Well Name: LOBO 33/28 B3OB FED COM	Well Location: T21S / R32E / SEC 33 / SWSE / 32.4283577 / -103.6769495	County or Parish/State: LEA / NM
Well Number: 1H	Type of Well: OIL WELL	Allottee or Tribe Name:
Lease Number: NMNM086710	Unit or CA Name:	Unit or CA Number:
US Well Number:	Operator: MEWBOURNE OIL COMPANY

Notice of Intent

Sundry ID: 2797671

PECOS DISTRICT DRILLING CONDITIONS OF APPROVAL

Figure 1. BOP diagram

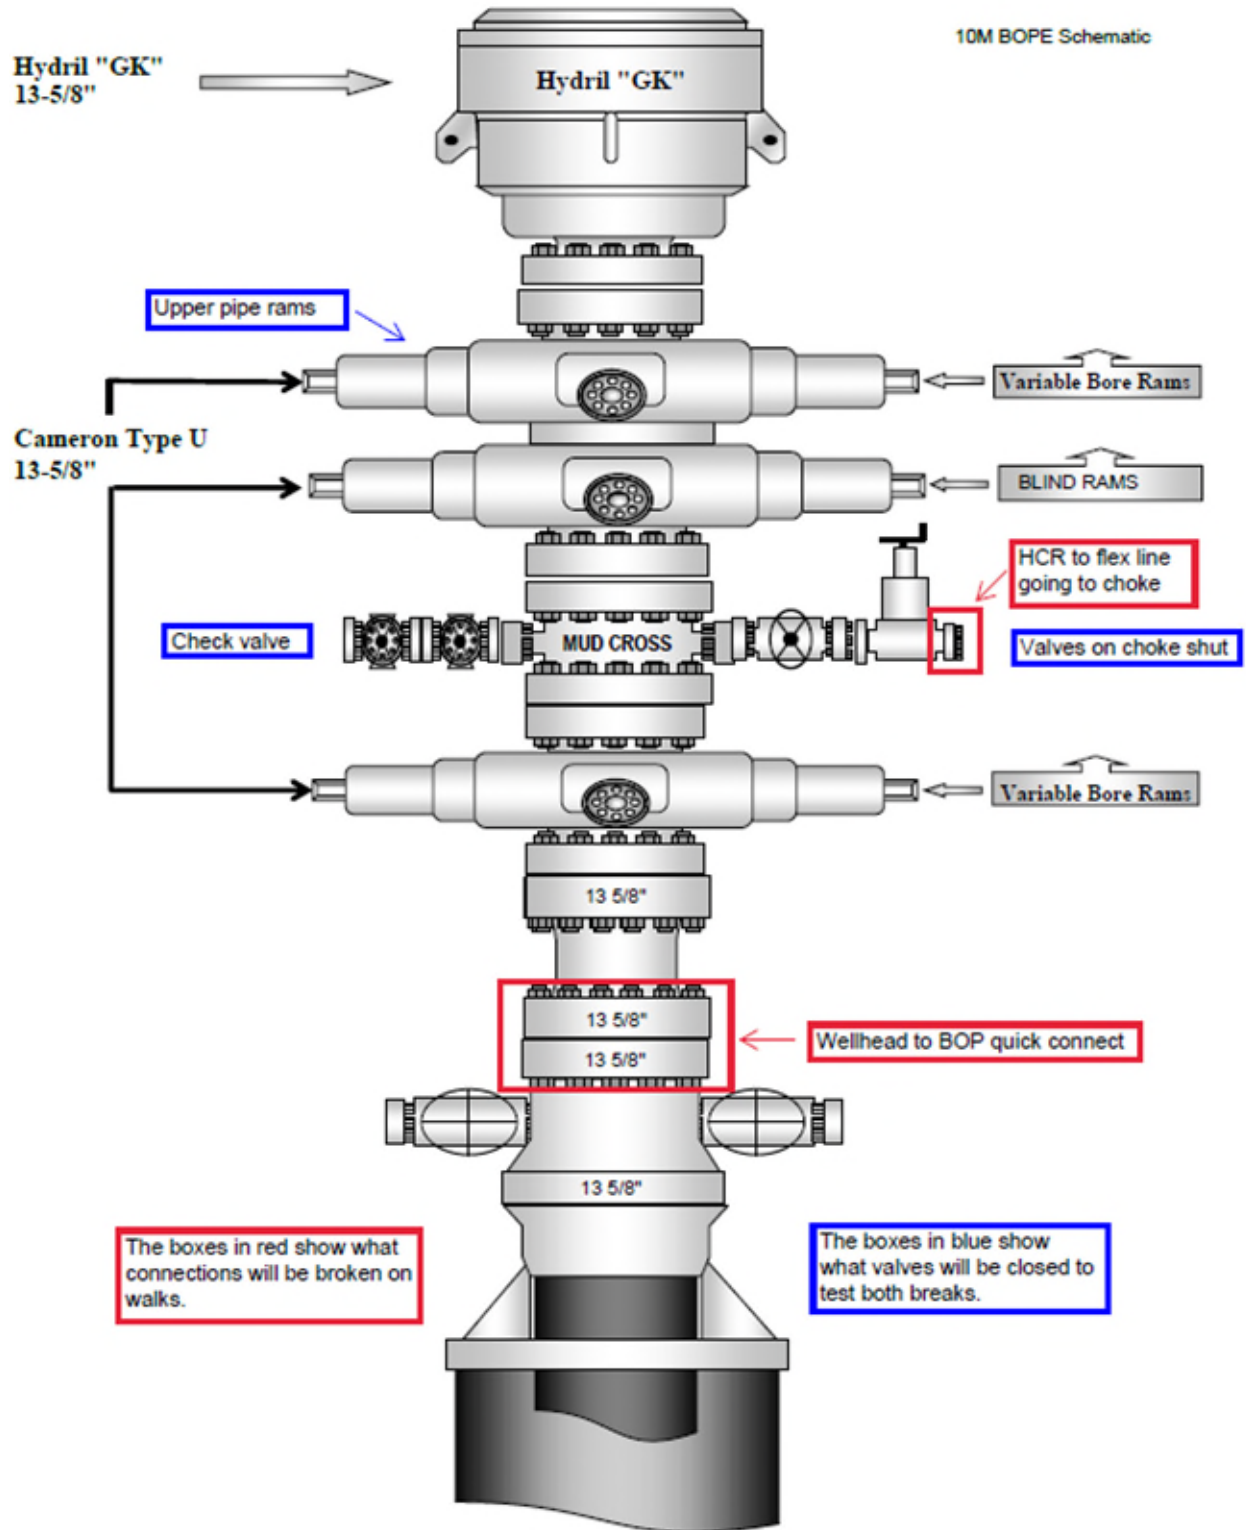
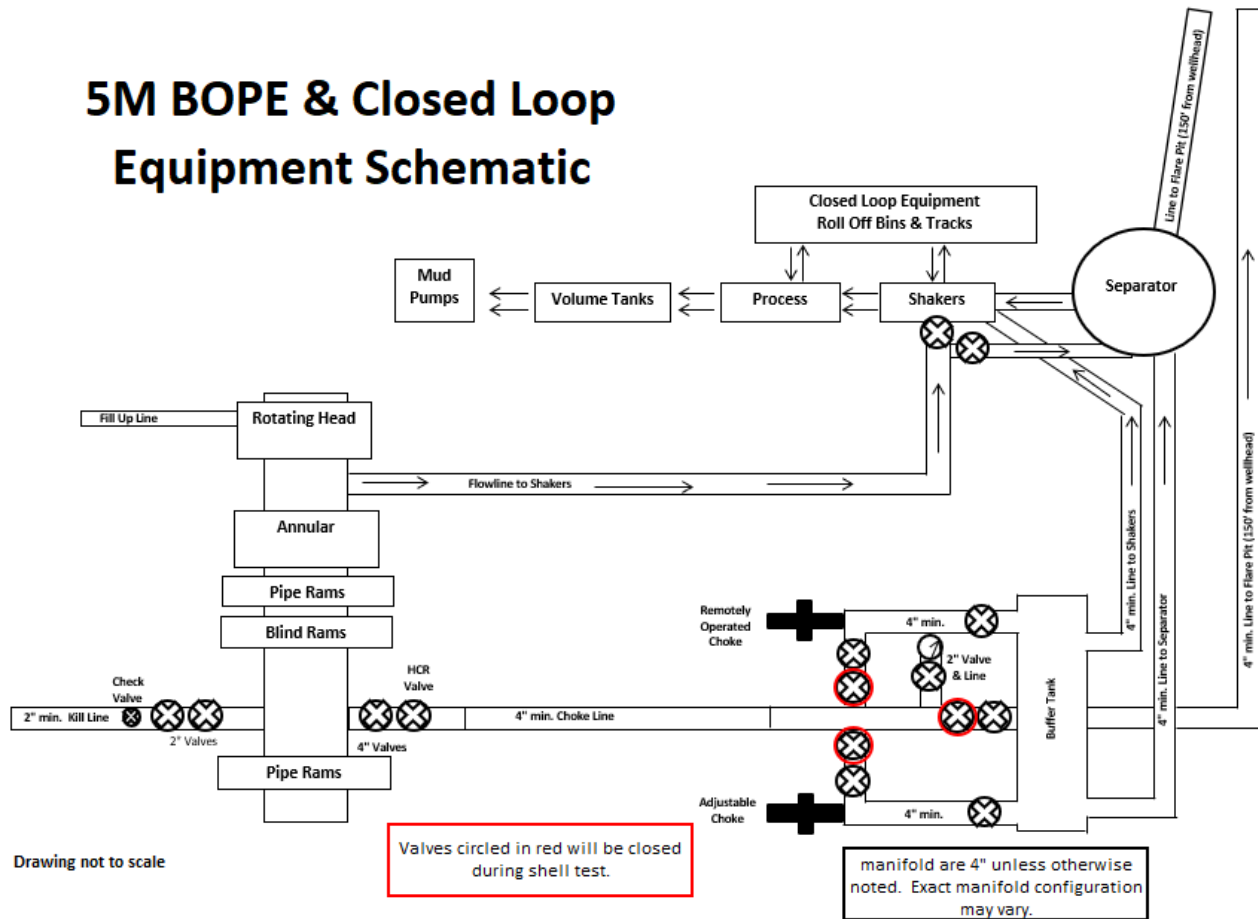
2. After the well section is secured and the well is confirmed to be static, the BOP will be disconnected from the wellhead and walked with the rig to another well on the pad. Two breaks on the BOPE will be made (Fig. 1).

9. A test will then be conducted against the upper pipe rams and choke, testing both breaks (Fig. 1 & 2).
10. The test will be held at 250 psi low and to the high value submitted in the APD, not to exceed 5000 psi.

Figure 3. BOP handling system

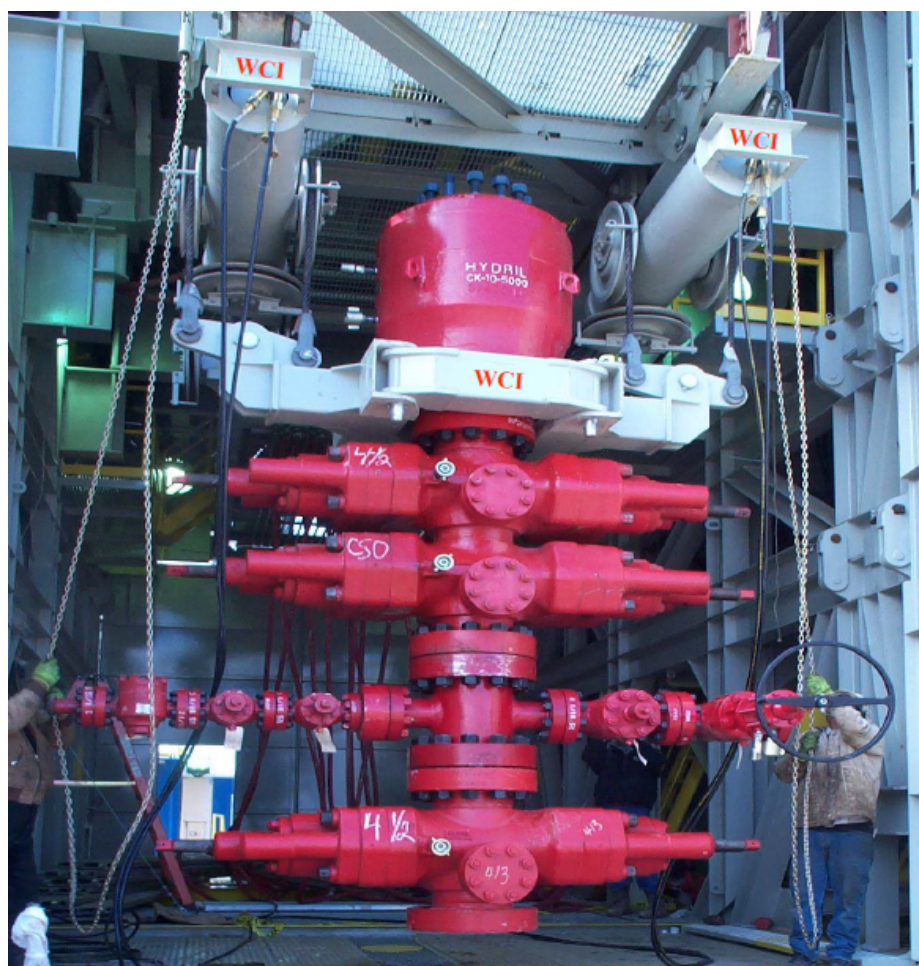
4. The BOP will be removed and carried by a hydraulic carrier (Fig. 3 & 4).
5. The rig will then walk to the next well.
6. Confirm that the well is static and remove the capping flange.

Figure 5. Cactus 5M wellhead with BOP quick connect

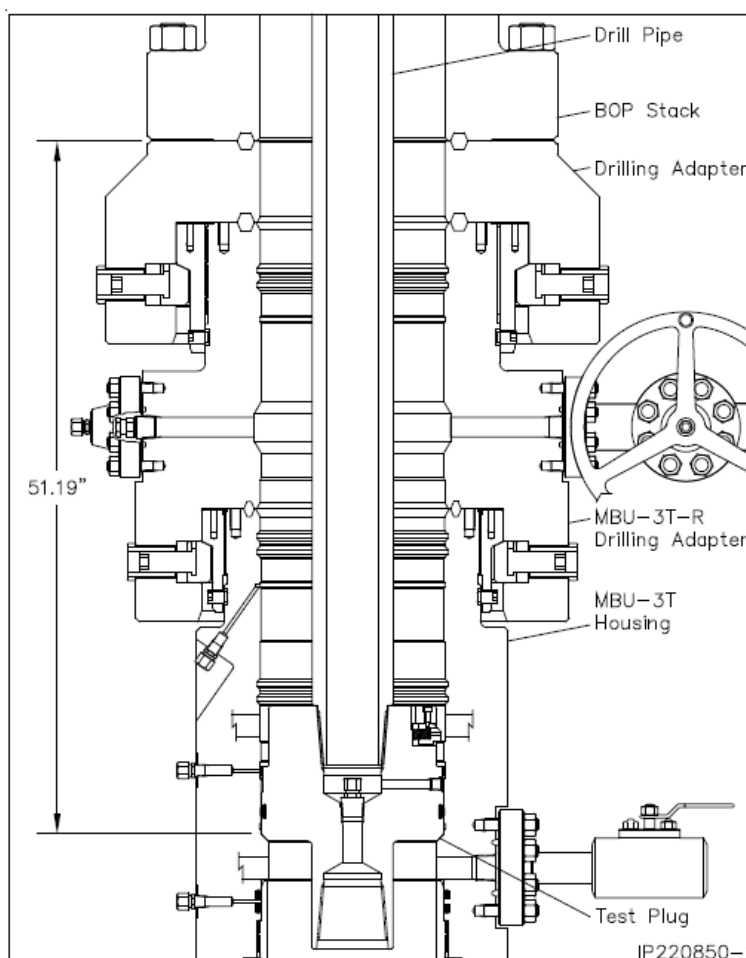
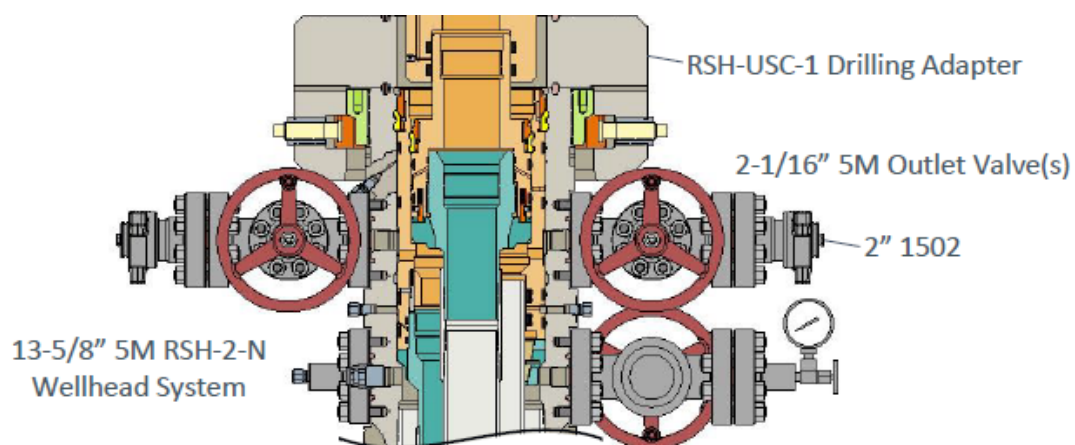
- Connection between the flex line and the HCR valve
 - Connection between the wellhead and the BOP quick connect (Fig. 5 & 6).
3. A capping flange will be installed after cementing per wellhead vendor procedure & casing pressure will be monitored via wellhead valve.

Figure 1. Cactus 13 3/8" 5M offline cementing tool. Pressure rating limited by the lesser of 5M tool rating or the 13 3/8" pup joint and casing.

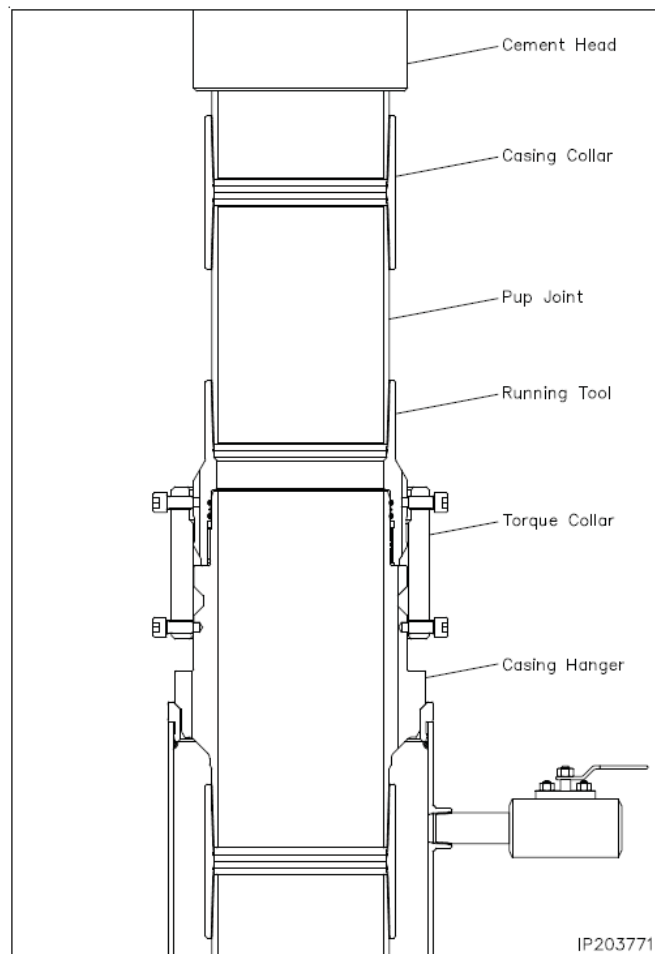
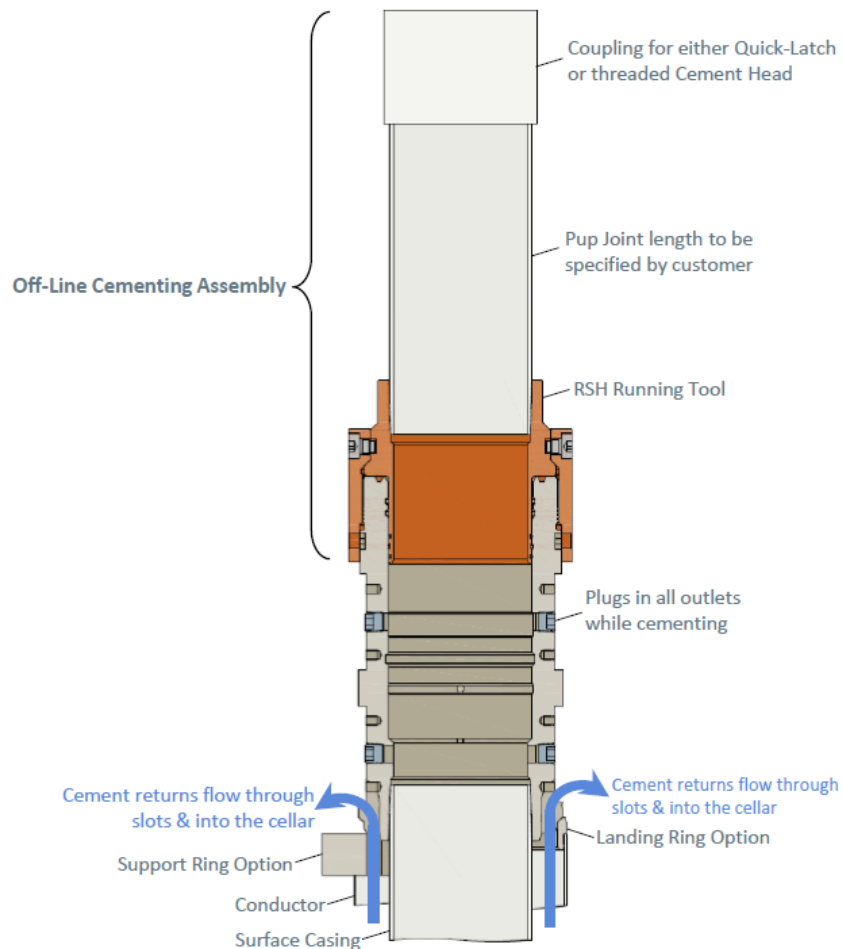
9. Make up offline cement tool with forklift per wellhead manufacturer (Fig. 1 & 2).
10. Make up cement head on top of offline cement tool with forklift.
